Re: Contra Costa Water District Comments on Bay Delta Conservation Plan and Draft EIR/EIS

Contra Costa Water District
 Comments on the December 13, 2013
 Draft Bay Delta Conservation Plan and Accompanying Draft EIR/EIS

Figure 1-1. Effect of tidal marsh restoration on Delta salinity depends on location of proposed tidal marsh and connectivity to the channels.
Adapted from RMA, 2013, slides 15 and 19.

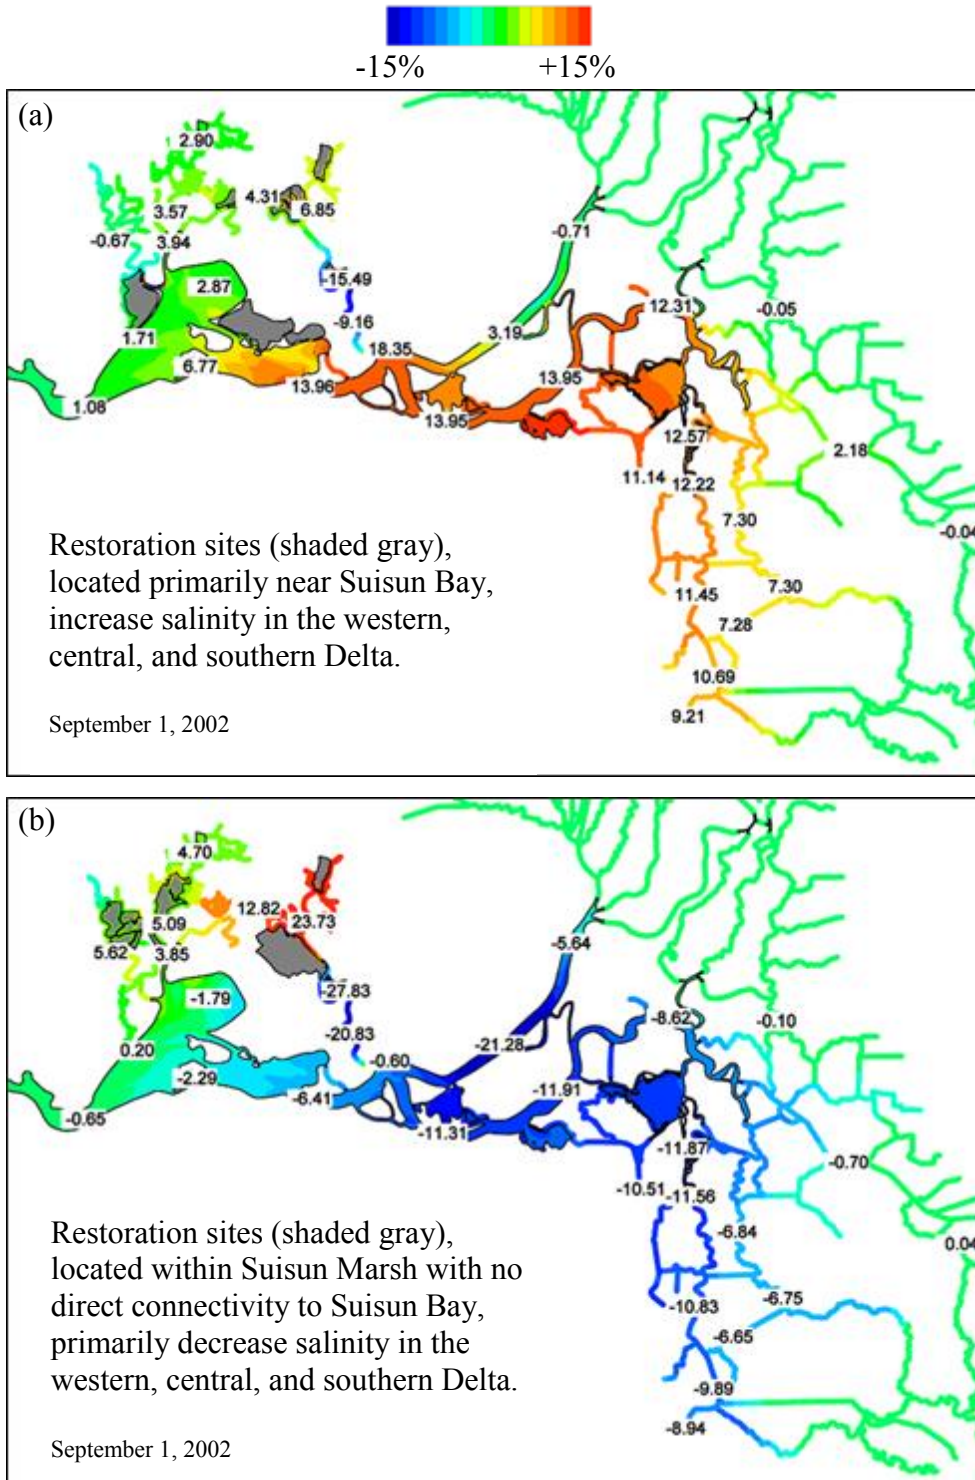
Location and connectivity. The location of proposed tidal marsh and its connectivity to the existing Delta channels have a large effect on the movement of water and mixing of water quality constituents, such as salt. For instance, analysis of two different groups of restoration sites in Suisun Marsh reveals dramatically different changes to salinity in the Delta (RMA, 2013). As shown in Figure 1-1 (panel (a) – top map), the group of restoration sites located primarily adjacent to Suisun Bay would ***increase salinity*** in the western, central, and southern Delta, generally by 10 to 15 percent (top map). On the other hand, as shown in Figure 1-1 (panel (b) – bottom map), the group of restoration sites located farther north in Suisun Marsh, with no direct connectivity to Suisun Bay, would ***decrease salinity*** in the same region on the same day, generally by 10 to 20 percent.

Timing of implementation in relation to other habitat projects. Independent modeling performed for the Suisun Marsh EIS/EIR (Reclamation et al., 2011) shows that the order of implementation of restoration projects can have a large effect on water quality. The Suisun Marsh EIR modeled two broad swaths of areas containing multiple restoration sites and two smaller subsets where smaller individual sites were examined in isolation. The results show that the combination of individual restoration sites determines the overall water quality impact, depending on which projects are included and the order in which they are implemented. Some of the sites modeled would increase salinity in the western Delta by up to 12% while some would decrease salinity. Thus, if individual restoration projects that increase salinity were to be implemented at the same time, and before projects that decrease salinity were implemented, the increase in salinity would be substantial and municipal water users in the Delta would be significantly affected. However, if habitat restoration projects that decrease salinity were to be implemented before or in conjunction with other restoration projects that increase salinity, salinity effects could be regulated to avoid or minimize water quality degradation.

Figure 1-2. Potential benefits and impacts of restoration at Prospect Island depend on design elements regarding the connectivity of the interior island to the surrounding channels.

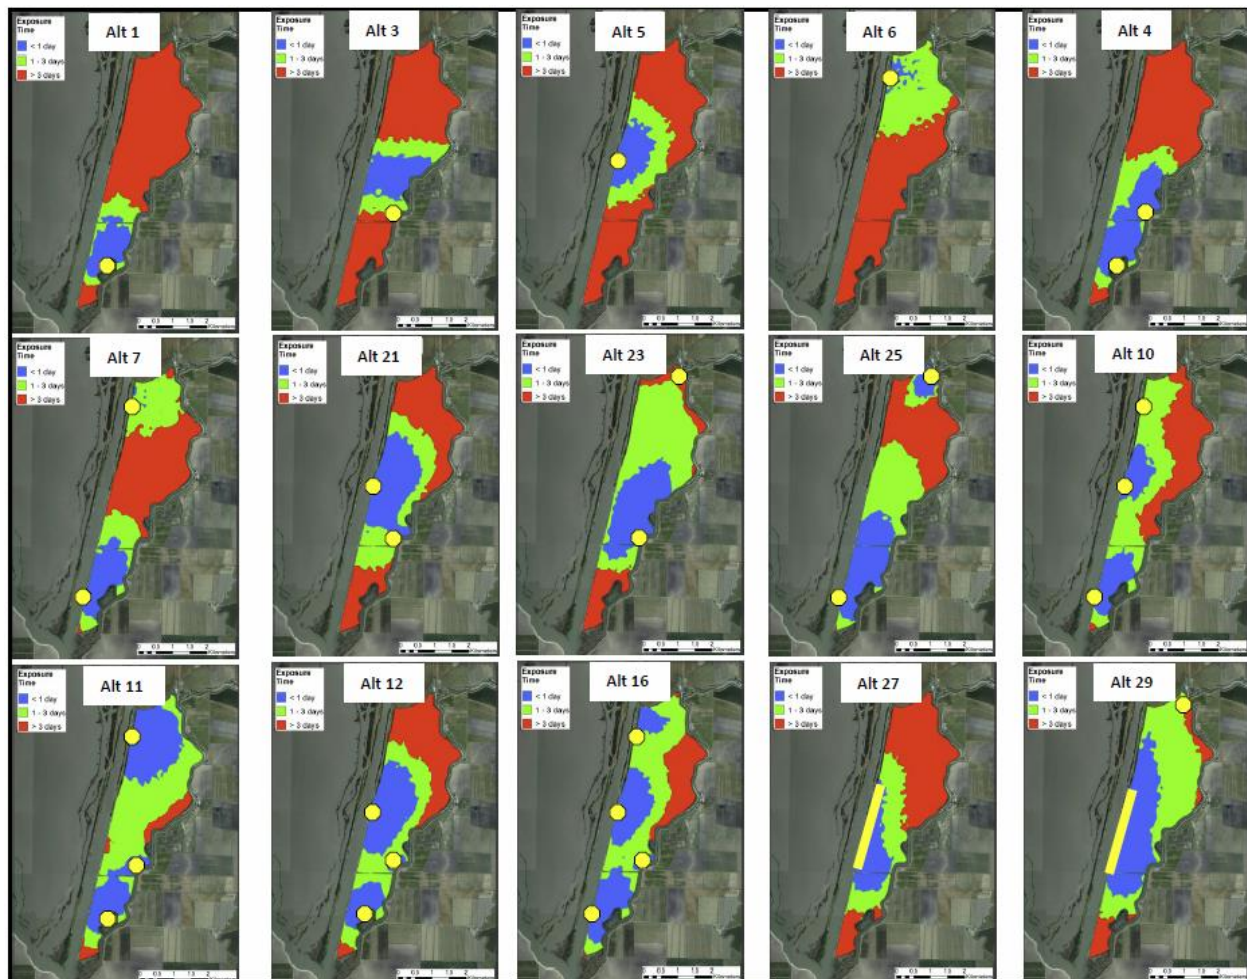
During screening level analysis, fifteen alternatives were evaluated to determine the potential to maximize food web productivity within the restoration site. The only difference between the alternatives was the location and size of breaches in the levees that surround Prospect Island and in a levee inside Prospect Island (RMA, 2013). The modeling results are presented in Figure 1-2, which depicts the areas of the restoration site as colored to show the type of algal community that would be likely to grow based on the simulated exposure time. As shown in Figure 1-2, the acreage that would be likely to produce benefits and the acreage that would be likely to produce adverse impacts varies widely between the alternatives that were studied. Although the focus of the analysis was the potential adverse or beneficial impact on covered fish, the production of different algal communities would also impact drinking water quality, as discussed in Section 2.2.1.2 of these comments.

Figure 1-3. Prospect Island and Liberty Island during a high outflow event illustrating (a) turbidity and (b) change in turbidity for two different habitat restoration alternatives on Prospect Island.

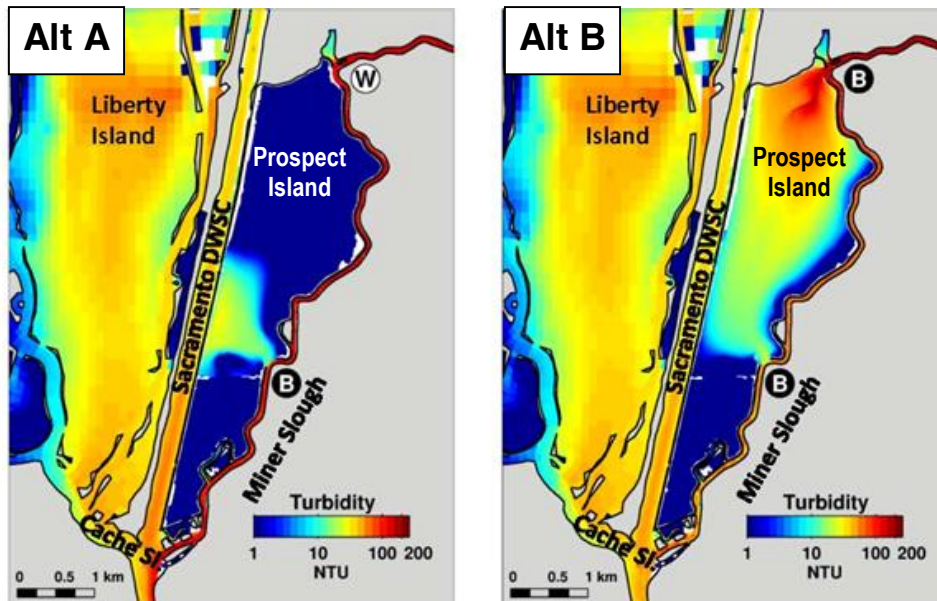
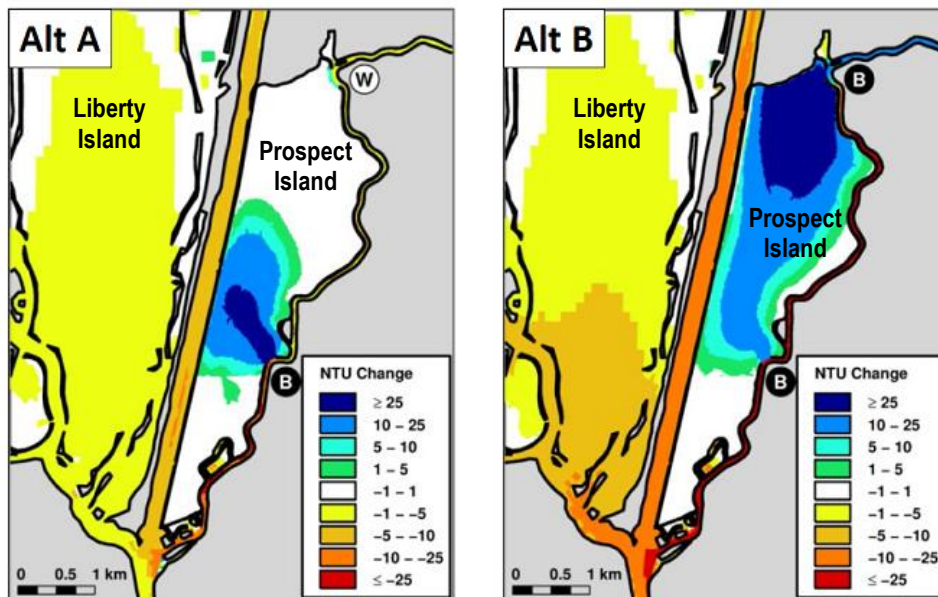
A more recent analysis of the Prospect Island Tidal Habitat Restoration Project evaluated the changes in turbidity that could result from a relatively minor change in the type of levee breach (MacWilliams et al., 2014). One of the alternatives in this analysis (Alternative A) would have a weir at the north of the island, while another alternative (Alternative B) would have a breach in the levee at the same location in the north end of the island. Thus, the difference between the two alternatives is the size of the connection between the restoration site and the adjacent channel. As shown in the first panel of Figure 1-3 below (panel (a)), turbidity under Alternative A would be up to 200 times lower in the north of the island than under Alternative B for the exact same flow conditions. Furthermore, as shown in the second panel of Figure 1-3 below (panel (b)), the change in turbidity due to the restoration action would extend outside of the restoration site. Although both alternatives would reduce turbidity in the region, Alternative B would have a much greater effect, reducing turbidity in the Deep Water Ship Channel by 10 to 25 nephelometric turbidity units (NTU) and reducing turbidity in lower Liberty Island by 5 to 10 NTU.

Additionally, the shape of the restoration site in relation to the dominant wind direction, the ground elevation, channel design, vegetation type, and relation to other restoration projects in the Delta all have a significant influence over the flows and water quality in the region. For example, in Mildred Island (which flooded in 1983, creating tidal habitat), the southeast corner of the habitat experiences the highest productivity due to the lack of flushing by tides and freshwater flows; yet when the dominant wind direction shifts, the area can be flushed, forcing exchange with nearby areas (Serenio et al., 2003). In Franks Tract, growth of submerged water weeds from the spring through early fall effectively channelizes the open water area. In late summer and fall when the weeds fill the full water column, residence time is increased within the vegetation and greatly reduced within the open water areas, with limited mixing between the regions (Serenio and Stacey, 2004). Due to the longer residence time and limited mixing, waters within the vegetation are warmer than the adjacent open water, and as salinity intrudes during the fall, salinity in the open water areas is greater than it would be without the vegetation.

Figure 2-1. Drinking Water Intakes in the Delta.

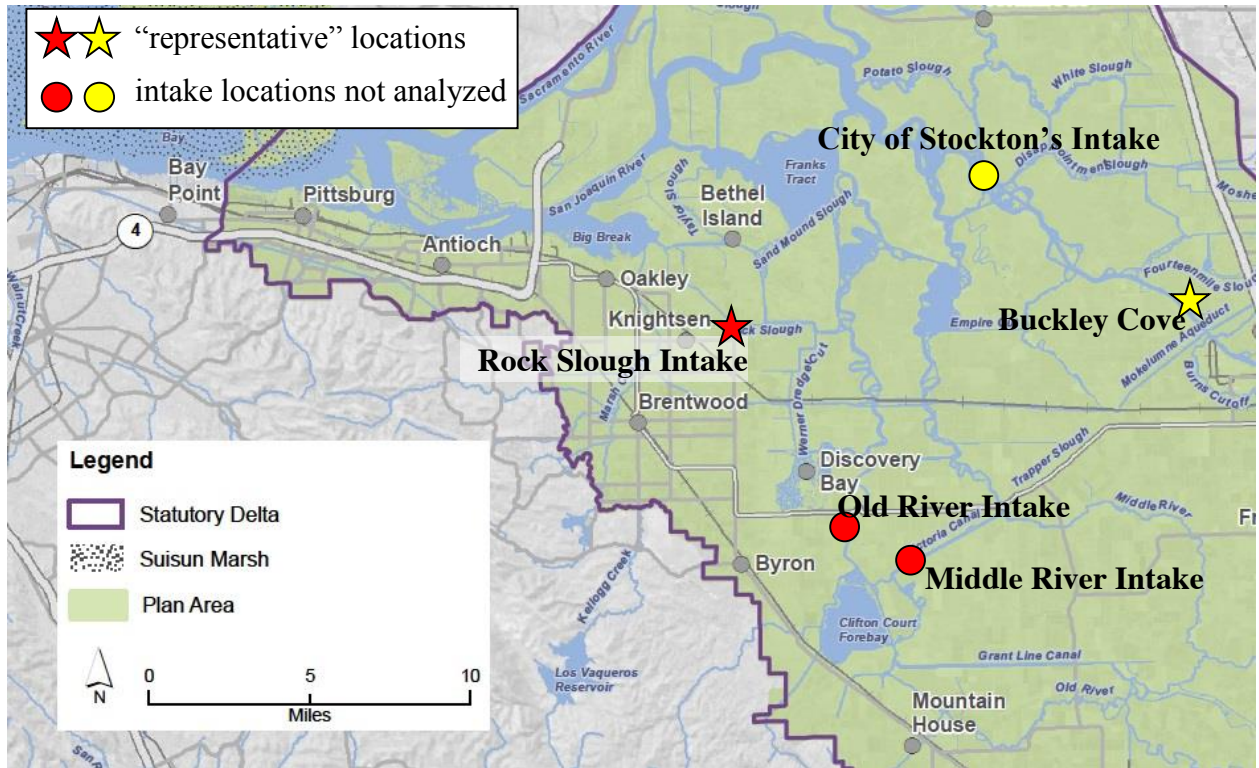
The BDCP Draft EIR/EIS inappropriately assumes that water quality at one location is representative of other locations, stating “[f]or municipal intakes located in the Delta interior, assessment locations at Contra Costa Pumping Plant No. 1 and Rock Slough are taken as representative of Contra Costa’s intakes at Rock Slough, Old River and Victoria Canal, and the assessment location at Buckley Cove is taken as representative of the City of Stockton’s intake on the San Joaquin River.” BDCP Draft EIR/EIS, Chap. 8 at pp. 8-149 and 8-162. This assumption is unreasonable. The actual intakes and their “representative” locations are up to 17 river miles apart (Figure 2-1). Hydrodynamic and water quality conditions vary widely within the Delta; indeed, it is the difference in salinity at different locations in the Delta interior that drove CCWD’s construction of its Old River intake and Middle River intake on Victoria Canal (collectively “Old and Middle River intakes”). Even intakes that are relatively close together such as CCWD’s Old and Middle River intakes have very different water quality because of the complexity of the hydrodynamics in the Delta (CCWD and Reclamation, 2006, Exhibit ES-2 at p. ES-5).

In fact, the differences in the quality of water at the “representative” sites in comparison to the actual intake locations were readily available to the BDCP consultants because the modeling that was used as the basis for the BDCP Draft EIR/EIS analysis includes results for water quality constituents at both the “representative” sites and at the actual intake locations. This modeling was provided by the DWR to CCWD in 2013 (DWR, 2013b). Plots of salinity variation in time at each location illustrate that the “representative” sites are, in fact, not representative of the actual intake sites. For instance, in the No Action Alternative, the salinity at Buckley Cove is dramatically different than the salinity at the City of Stockton’s intake (Figure 2-2). Similarly, in the No Action Alternative, salinity at the Rock Slough intake would at times be up to 800 microsiemens per centimeter greater than salinity at the Middle River intake; while at other times, salinity at the Middle River intake would be up to 200 microsiemens per centimeter greater than at the Rock Slough intake (Figure 2-3); neither the seasonal pattern nor the annual maximum and minimum values of salinity coincide temporally at these sites. Given the differences in salinity under the No Action Alternative between the “representative” sites and the actual intake locations,

it is not appropriate to use the “representative” sites to assess impacts at drinking water intakes when modeling results for the actual intake sites are readily available.

Figure 2-2. Salinity at the City of Stockton’s intake and Buckley Cove

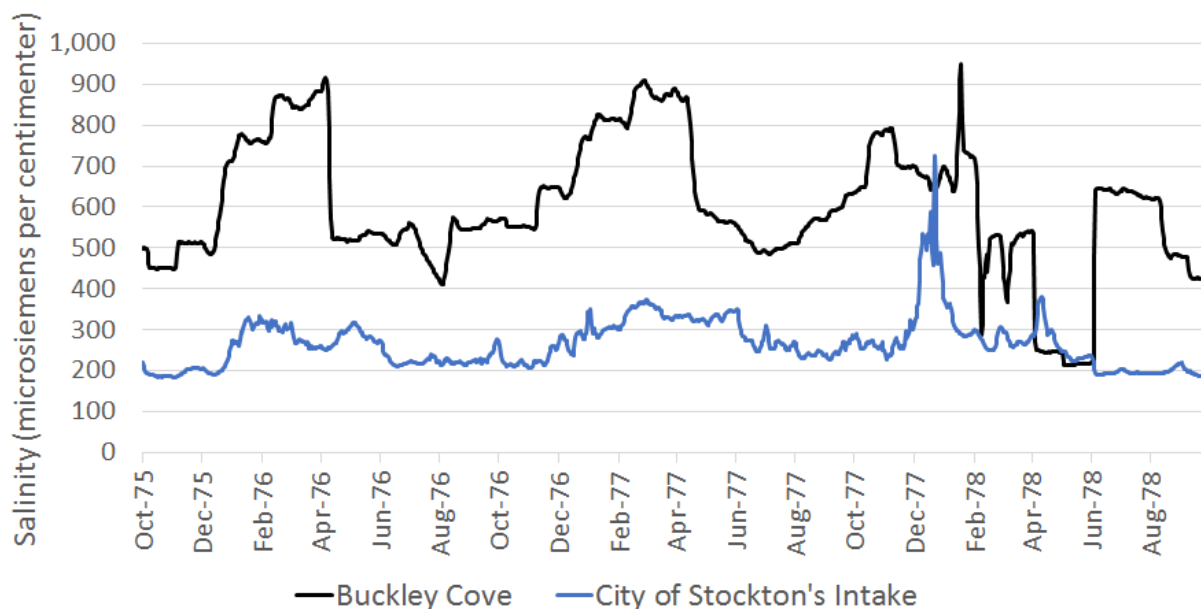
Results from modeling of the No Action Alternative, performed for BDCP Draft EIR/EIS and provided to CCWD by DWR (DWR, 2013b), illustrate that salinity at the City of Stockton’s intake differs significantly from salinity at the Buckley Cove. The quality of water at the Buckley Cove is not representative of the City of Stockton’s intake.

Figure 2-3. Salinity at CCWD’s Rock Slough, Old River, and Middle River intakes

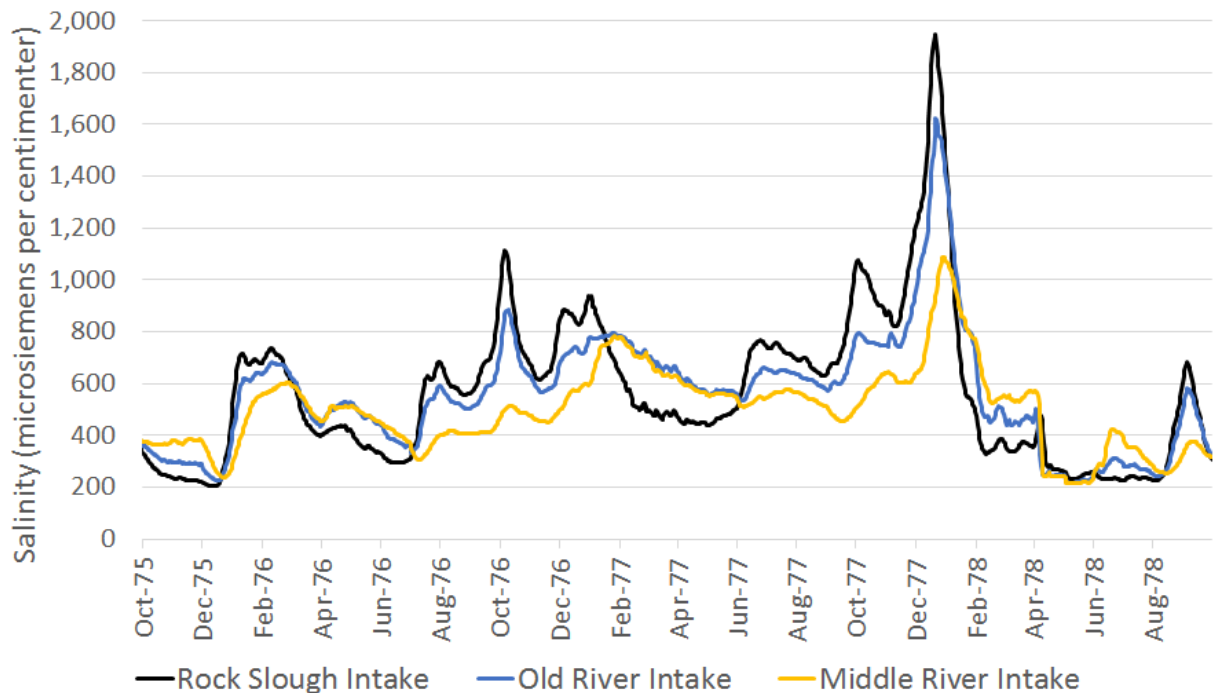
Results from modeling of the No Action Alternative, performed for BDCP Draft EIR/EIS and provided to CCWD by DWR (DWR, 2013b), illustrate that salinity at the Rock Slough intake differs significantly from salinity at the Old River intake and Middle River intake. The quality of water at the Rock Slough intake is not representative of the other two intakes.

The differences in the quality of water at different locations in the Delta interior is partially due to the difference in the source of the water. For instance, some locations within the Delta interior are dominated by water that originated on the Sacramento River, while other locations are dominated by water from the San Joaquin River and still other locations are dominated by water from the Bay; the magnitude of local agricultural drainage also varies from place to place. The mixture varies spatially and temporally as river flows and tidal dynamics change throughout the seasons and between years. The modeling that was used as the basis for the BDCP Draft EIR/EIS analysis (DWR, 2013b) calculates the fraction of water that originates from the upstream rivers and the downstream bay at both the “representative” sites and at the actual intake locations. Plots of the percentage of water at each location that entered the Delta from the Sacramento River water illustrate that the “representative” sites are, in fact, not representative of the actual intake sites because the makeup of the water at each location is dramatically different. For instance, Figure 2-4 shows that the location of the City of Stockton’s intake often receives greater than 70% of its water from the Sacramento River, while Buckley Cove seldom receives any water from the Sacramento River.

Figure 2-4. Percent of water at the City of Stockton’s intake and Buckley Cove that originated on the Sacramento River

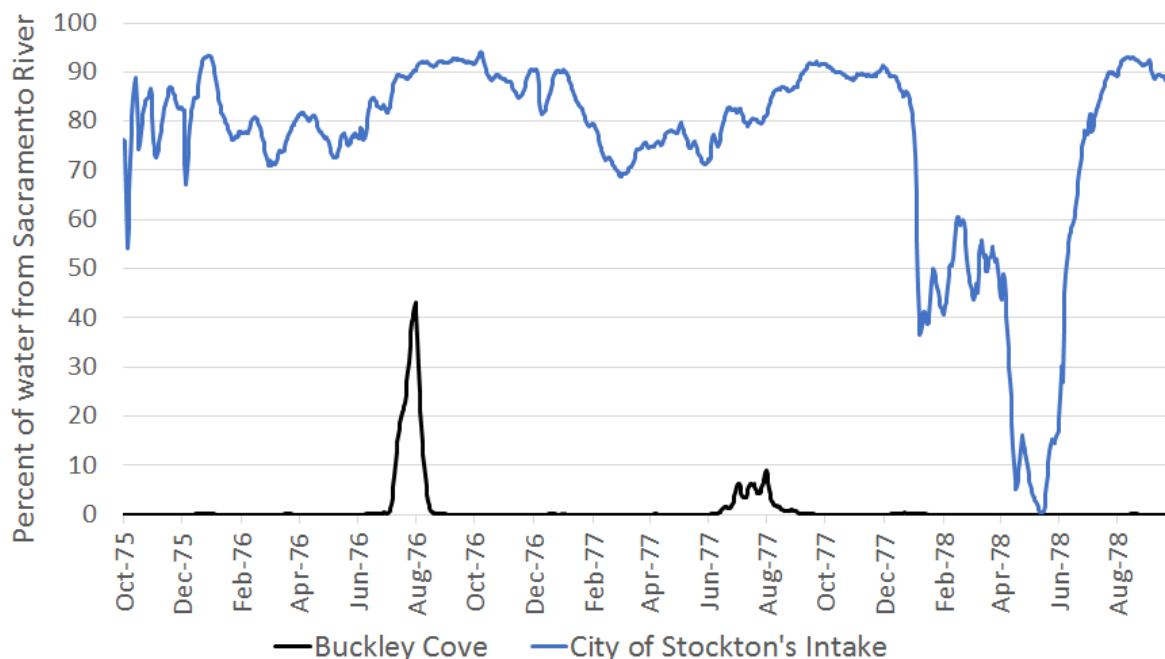
Since all of the BDCP alternatives propose either to divert Sacramento River water before it enters the central Delta (Alternatives 1 through 8) or to construct numerous barriers that would alter the mixing of river and bay waters (Alternative 9), the BDCP would impact the mixture of water at all locations within the interior Delta. Because of the complicated nature of the movement and mixing of waters within the Delta, the impact would vary by location. For this reason, it is not appropriate for the BDCP Draft EIR/EIS to use “representative” sites when information at actual intakes sites is readily available.

Results from modeling of the No Action Alternative, performed for BDCP Draft EIR/EIS and provided to CCWD by DWR, illustrate that the percent of water that originated on the Sacramento River varies dramatically between the City of Stockton’s intake and the “representative” site at Buckley Cove.

Figure 2-5. Impact to CCWD’s delivered water quality

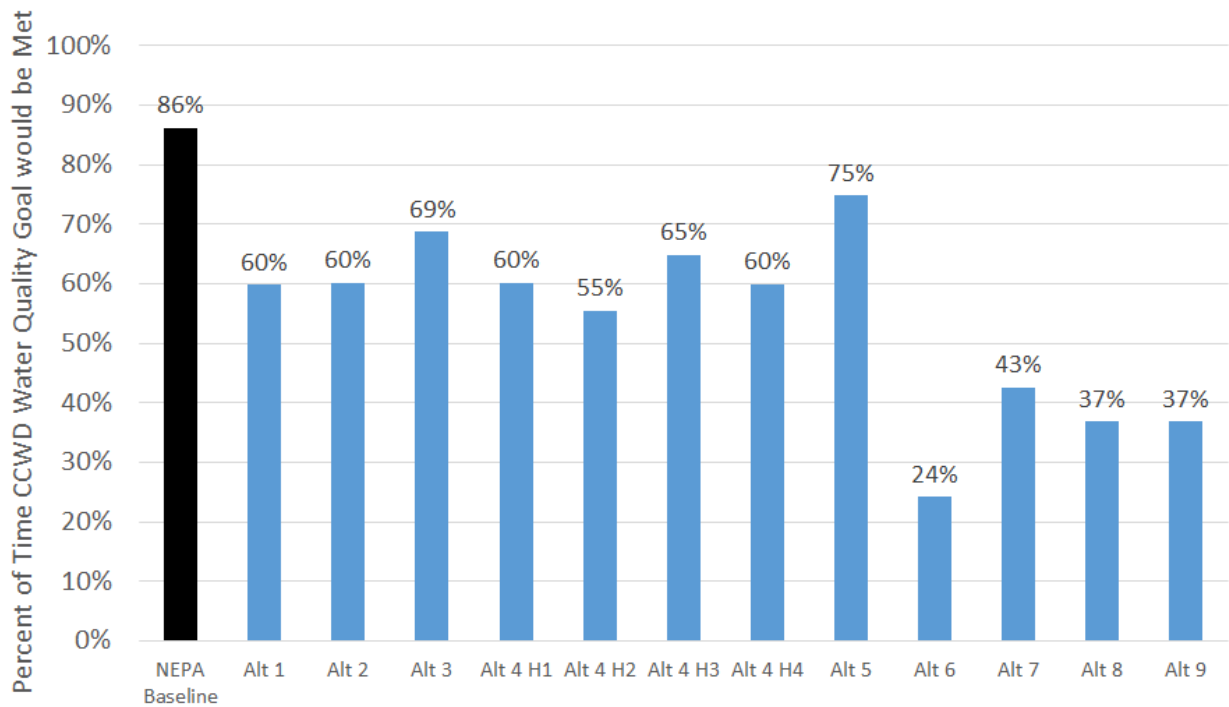
As illustrated in Figure 2-5, the percent of the time that CCWD could meet its water quality goal of 65 mg/L chloride concentration would be reduced in every alternative in comparison to the NEPA baseline.¹⁸ For instance, CCWD would be able to meet its water quality delivery goal 86% of the time under the No Action Alternative, but under Alternative 4 the delivery goal would be met only between 55% and 65% of the time, depending on the operational scenario (H1 through H4).
